Planning Commission Staff Report

Meeting Date: September 23, 2019

Petition: **P.Z. 04-2019 13559 Olive Blvd (McDonald's)**: A request for a zoning map amendment from a "C8" Planned Commercial District to a "PC" Planned Commercial District for a .86 tract of land located north of Olive Blvd., west of its intersection with North Woods Mill Rd. (16Q241471)

ORDER STATION SOUND LEVELS

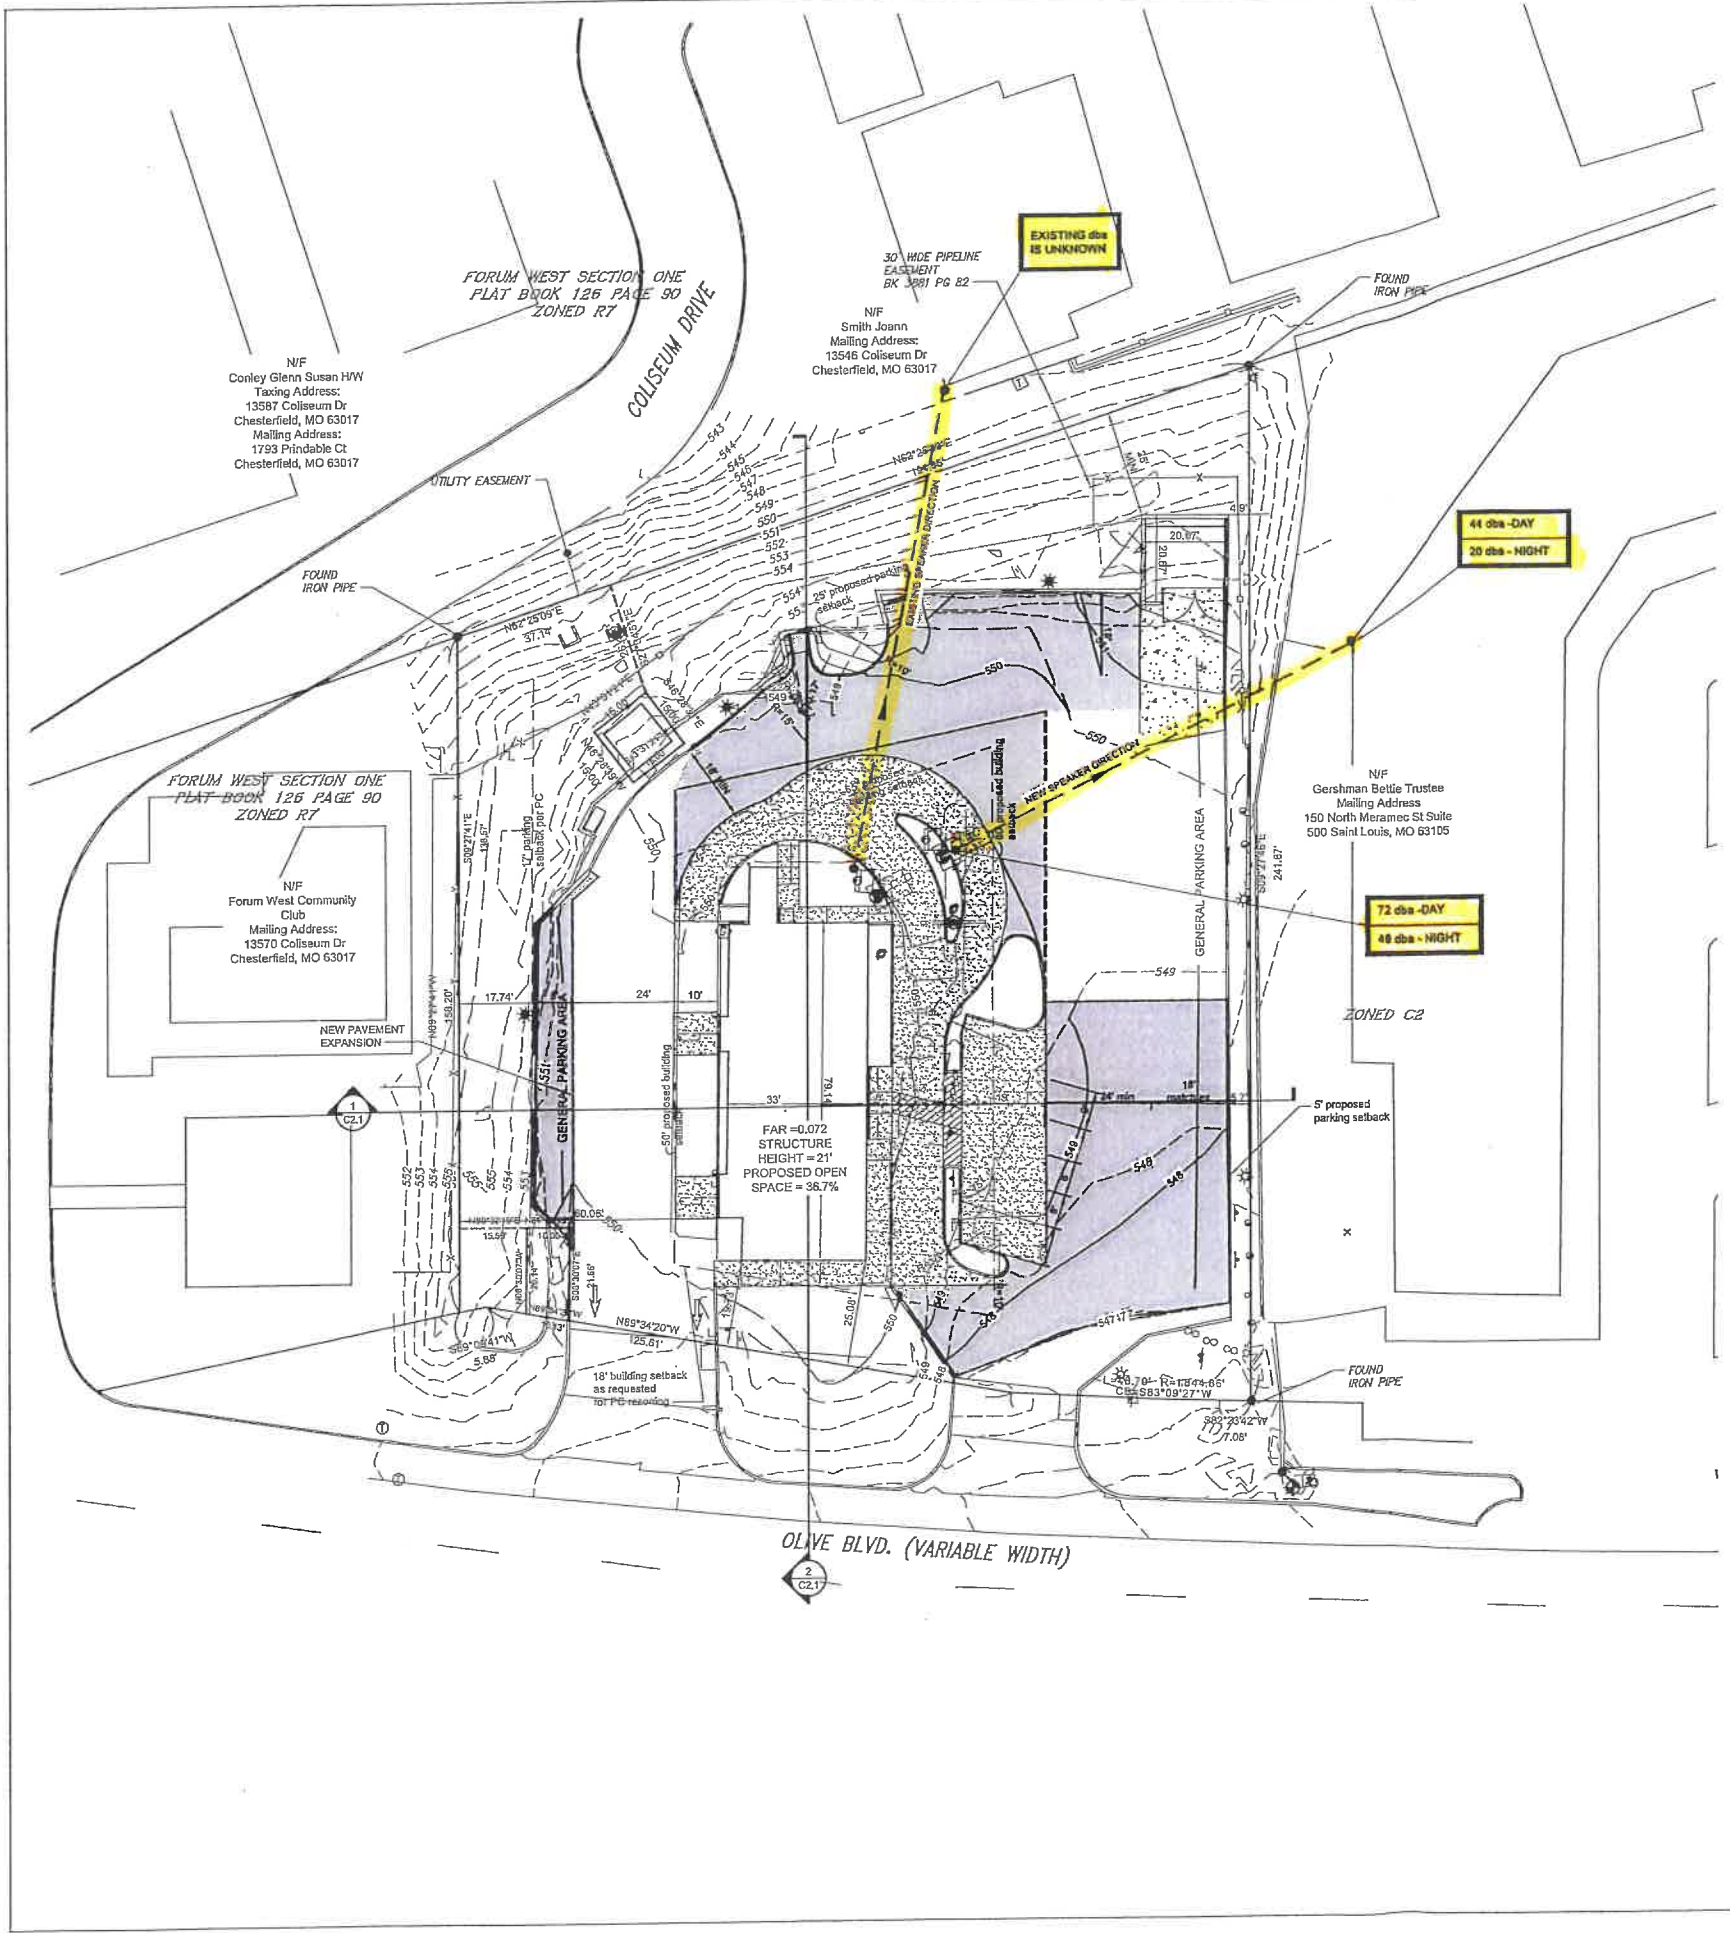
1. **Sound**- Both the Planning Commission and the members of the public identified the concern of noise levels given the proximity to residential neighborhoods.
 - Confirm the sole area on the site projecting outside sound from speakers will be from the double drive-thru ordering station. Given the double drive-thru ordering station is in a new location, describe how this will impact sound traveling through the site and the direct impact on the neighboring residents.
 - The current condition of the perimeter fence is in a less than desirable condition. Address the site's ability to upgrade the fence to a sound wall designed to specifically mitigate noise given the concern of increased hours of noise levels and the addition of the noise (order station) closer to the residents to the north.

Response – The applicant stated that the new order station will direct sound in a much more easterly direction towards the adjoining shopping center. The applicant has provided an exhibit depicting the existing and new directions of sound as well as the sound levels. The new speaker system also incorporates automatic volume control which is reduced during the night. The exhibit depicts that there will be no additional noise from the ordering stations on the neighboring residential properties.
